# 1987 - 1991 Corvette: Service Bulletin: 4L60 Low & Reverse Clutch New Plate Available

**Subject:** 4L60 LOW & REVERSE CLUTCH NEW WAVE PLATE IS AVAILABLE

**Model and Year:** 1987-91 CAPRICE, CAMARO, CORVETTE AND 1987-91 C/K, RN, S/T TRUCKS, G, M VANS AND 1990-91 L VAN WITH 4L60 AUTOMATIC TRANSMISSION

**Bulletin Number:** 91-186-7A - (01/29/1991)

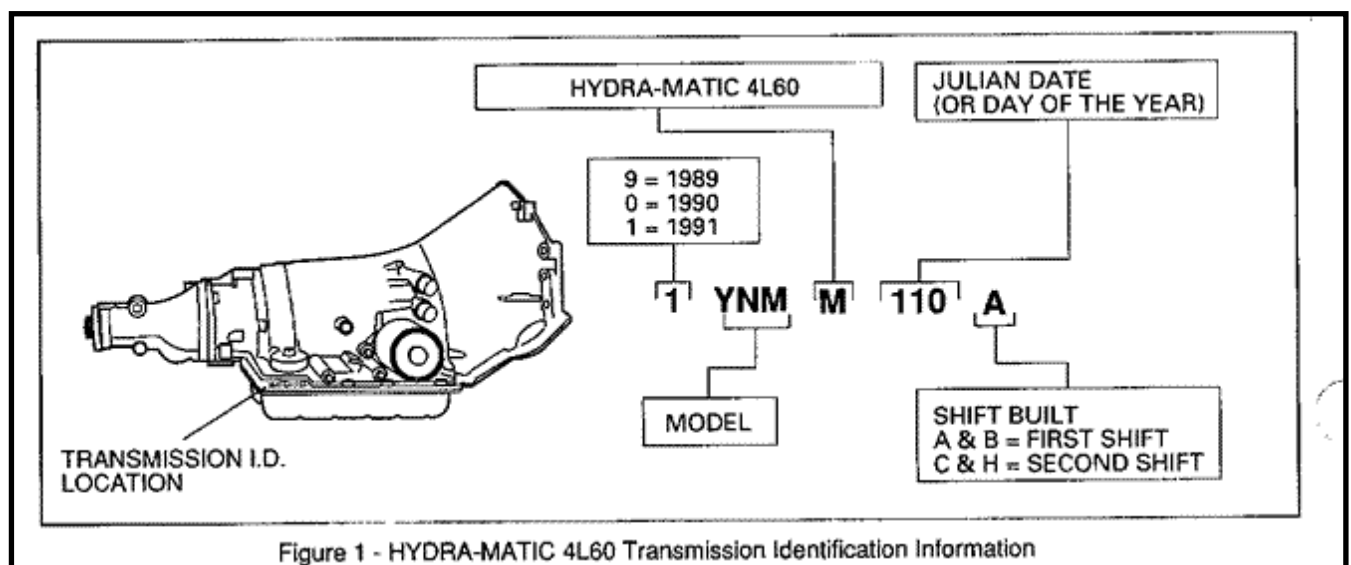
DATE OF PRODUCTION CHANGE: (Figure 1)

----- Beginning March 28,1990 (Julian Date 087),  
all HYDRA-MATIC 4L60 transmissions were built using the new low and  
reverse clutch wave plate.

Figure 2 - Lo And Reverse Clutch Waved Plate

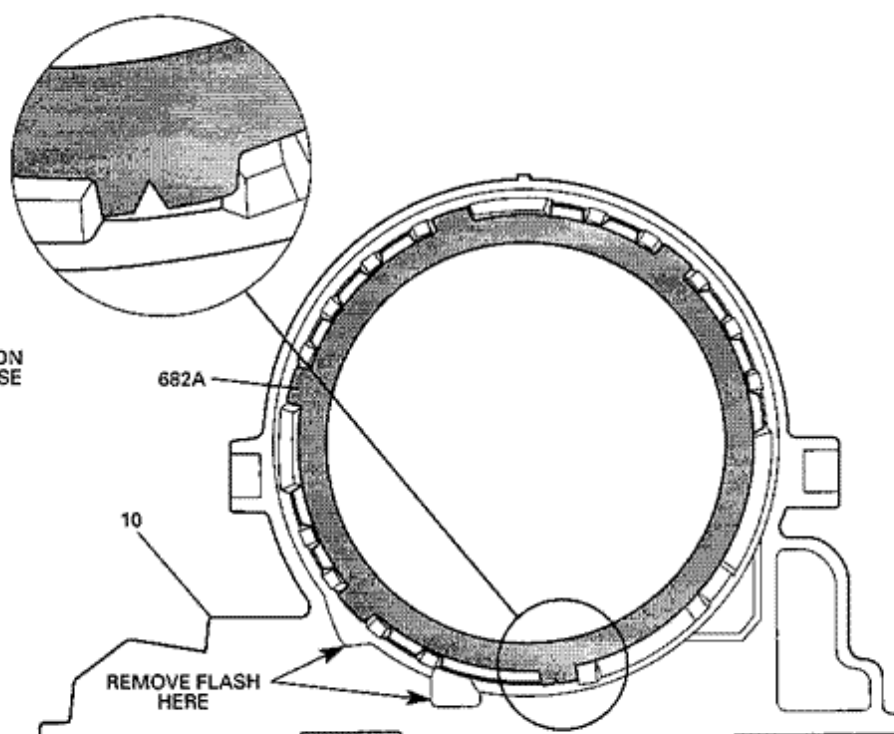
SERVICE INFORMATION: (Figure 2) ----- Low and Reverse Clutch failure can be caused by case casting flash interfering with clutch plate travel. A new wave plate is now available which will alleviate this condition. This new plate can be used to service any Hydra-matic 4L60 transmission produced after February 9, 1987 (Julian Date 040).

When installing the new wave plate, check for any case flash that may be present in the low and reverse grooves, and use a metal file to remove. See Figure 2 for case location information.

Plate - Low and Reverse (wave) 8676362
